FirstEnergy Nuclear Operating Company

Subject: Beaver Valley Power Station, Unit Nos. 1 and 2
BV-1 Docket No. 50-334, License No. DPR-66
BV-2 Docket No. 50-412, License No. NPF-73
Supplemental Information – EPU Implementation Plan & Power Ascension
Testing: License Amendment Request Nos. 302 and 173 (Unit No. 1 TAC
No. MC4645/Unit No. 2 TAC No. MC4646)

EPU Implementation Plan & Power Ascension Testing for BVPS-1 & BVPS-2

Figure 1 - Power Ascension Profile & Testing Plateaus (BVPS-1)
(NOTE - Timelines Not Drawn To Scale)

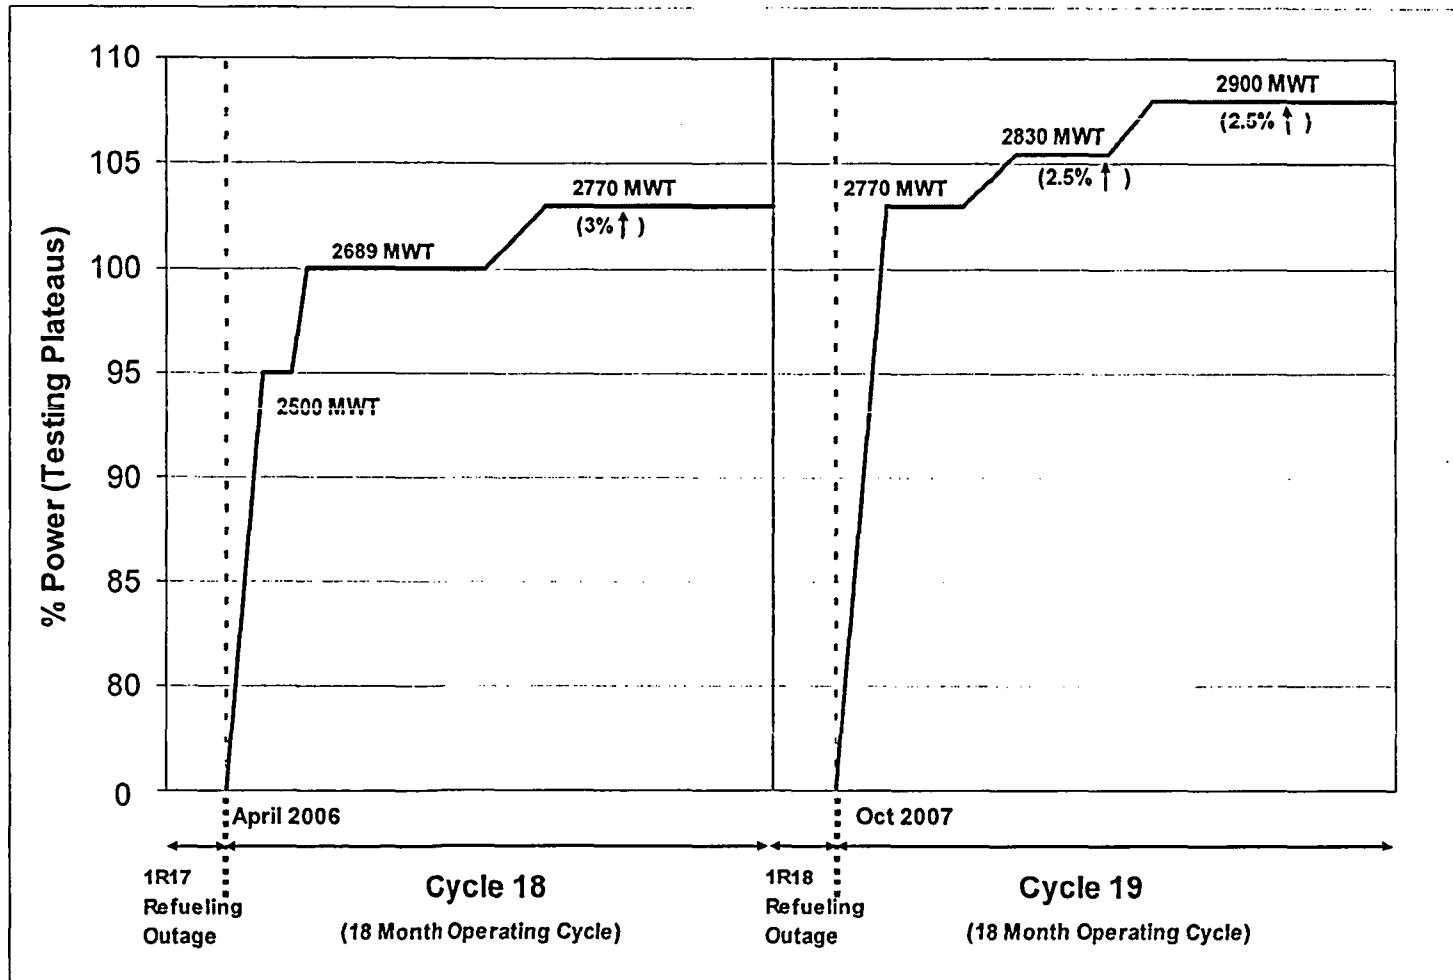
The BVPS-1 Containment Conversion (CC), Best Estimate LOCA (BELOCA), and the Replacement Steam Generator (RSG) License Amendments will be implemented during refueling outage 1R17 at the current licensed Rated Thermal Power (RTP) level of 2689 MWt. The Extended Power Uprate (EPU) power ascension will occur following 1R17. Figure 1 provides a profile of the projected power ascension and testing plateaus for BVPS-1.

The 1st stage will be implemented on-line during Cycle 18 (following 1R17) by increasing RTP to 2770 MWt.

The 2nd stage will be implemented in a subsequent operating cycle (following 1R18) to increase the RTP to the uprated reactor power level of 2900 MWt. This implementation will be completed in two steps of approximately 2.5% each.

Figure 2 - Power Ascension Profile & Testing Plateaus (BVPS-2)
(NOTE - Timelines Not Drawn To Scale)

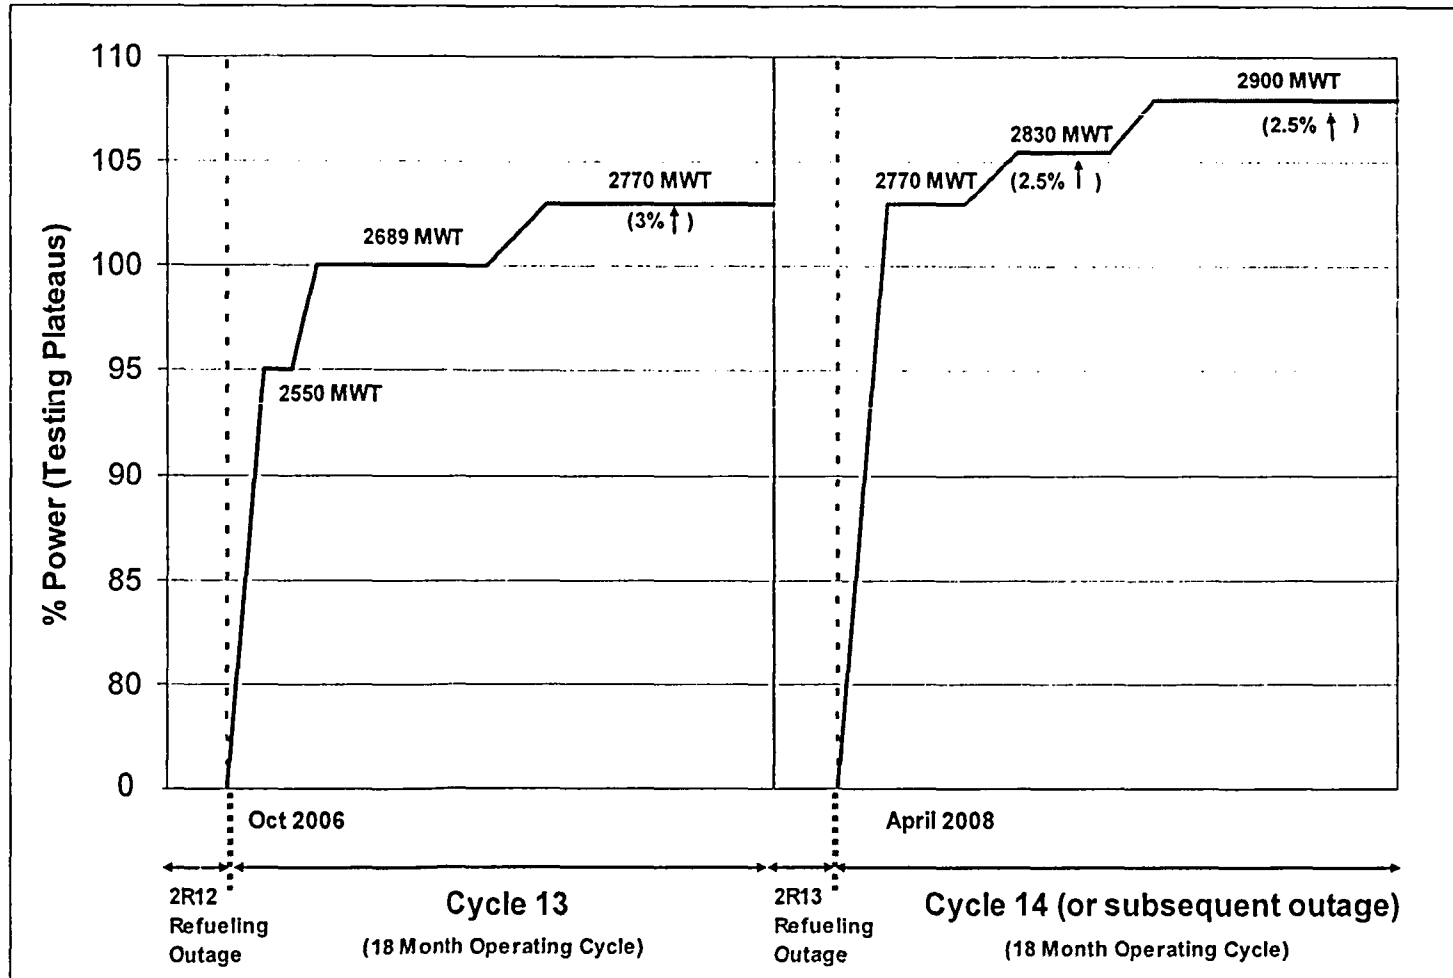
The BVPS-2 Containment Conversion (CC) and BELOCA License Amendments will be implemented during refueling outage 2R12. The EPU power ascension will begin following 2R12 and will also be implemented as a phased approach in two stages. Figure 2 provides a profile of the projected power ascension and testing plateaus for BVPS-2.

Prior to the BVPS-2 shutdown for 2R12, data will be recorded at the current reactor power level of 2689 MWt. This data will be used as a "baseline" to predict operating values at 2770 MWt (3% increase). During power ascension from the refueling outage 2R12, plant data will be recorded at approximately 2550 MWt (95% of 2689 MWt) and then at 2689 MWt. This data will be used to predict values at 2770 MWt during subsequent power ascension. Power will be increased in a controlled manner, and required parameters will be monitored. As stated above for BVPS-1, parameters are assigned levels of significance to aid in determining the appropriate response if a parameter differs from expectations and does not meet acceptance criteria. Upon reaching 2770 MWt, parameters will be monitored to confirm that the expectations and acceptance criteria have been met.

During a subsequent refueling outage, a new high pressure (HP) turbine rotor, similar to that installed in BVPS-1, will be installed in BVPS-2 to allow increasing power above 2770 MWt. Following return to power after the subsequent refueling outage, data will be recorded at 2770 MWt. Power will be increased to 2830 MWt and held while data is taken to assure that the unit is safe for further power ascension to 2900 MWt. As was done for the 1st stage, the power ascension will be monitored at each step to confirm that the values are as predicted and meet acceptance criteria.
